# Access Compliance Report

## Public Rights-of-Way

### (Curb Ramps)

Intersection ID: 4979	Main Street: BETTERTON_LN	Cross Street: CRISFIELD_RD	Location: SE
ADA ID: CEEE06A9AF7A	Ramp Type: Perp	Initial Pass/Fail: Fail	Overall Compliance: No
Severity Score: 26.25			
Codes/Mitigation Info/Possible Solution		Field Measurements/Component Compliance

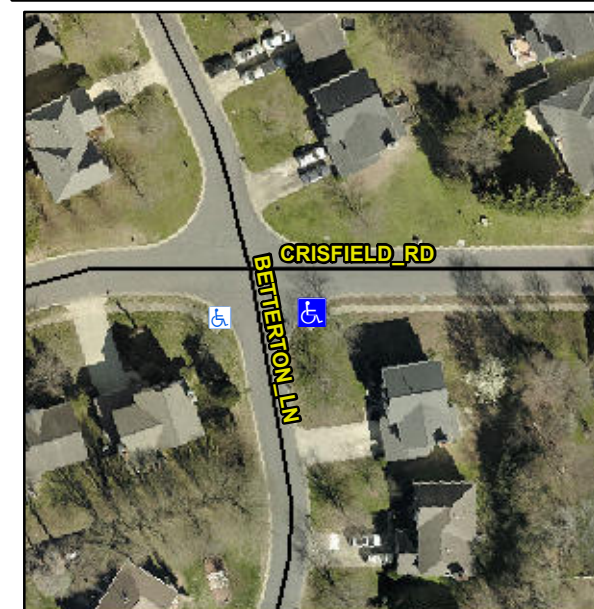
**R304.2.2, R304.5.3**

Compliance	Description	Data	Compliance	Description	Data
N/A	Ramp Length (in)	47.0	No	Ramp Slope (%)	17.8
Yes	Ramp Width (in)	48.0	No	Ramp XSlope (%)	2.3
N/A	Flare Type LT	N/A	N/A	Flare Type RT	N/A
N/A	Flare Slope LT (%)	N/A	N/A	Flare Slope RT (%)	N/A
N/A	Flare Traversable LT?	N/A	N/A	Flare Traversable RT?	N/A
N/A	Landing Length (in)	N/A	N/A	DWS Provided?	N/A
N/A	Landing Width (in)	N/A	N/A	DWS Contrast?	N/A
N/A	Landing Slope (%)	N/A	N/A	DWS Length (in)	N/A
N/A	Landing X Slope (%)	N/A	N/A	DWS Full Width?	N/A
N/A	Landing Curb? (Y/N)	N/A	N/A	DWS Offset (in)	N/A
N/A	Shared Landing?	N/A			
N/A	Gutter Ponding?	N/A	N/A	Gutter Slope (%)	N/A
N/A	Gutter Lip Ht (in)	N/A	N/A	Gutter X Slope (%)	N/A
N/A	Painted X Walk1?	No	N/A	Painted X Walk2?	N/A
	X Walk 1 Direction	To W		X Walk 2 Direction	N/A
N/A	X Walk 1 Width (in)	N/A	N/A	X Walk 2 Width (in)	N/A
	X Walk 1 Slope (%)	3.6		X Walk 2 Slope (%)	N/A
	X Walk 1 X Slope (%)	5.1		X Walk 2 X Slope (%)	N/A

N/A	Ramp inside XWalk1?	N/A	N/A	Ramp inside XWalk2?	N/A
	Road Slope (%)	N/A	N/A	Clear Space?	N/A
	Road X Slope (%)	N/A	N/A	Clear Space to XWalk (in)	N/A
N/A	Any Obstructions?	N/A	N/A	Storm Grate/Utility Hazard?	N/A
	Obstruction Type			Storm Grate/Utility Type	
		N/A			N/A
			Yes	Surface Condition? (G/P)	Good

**Remove & Replace Entire Ramp.**
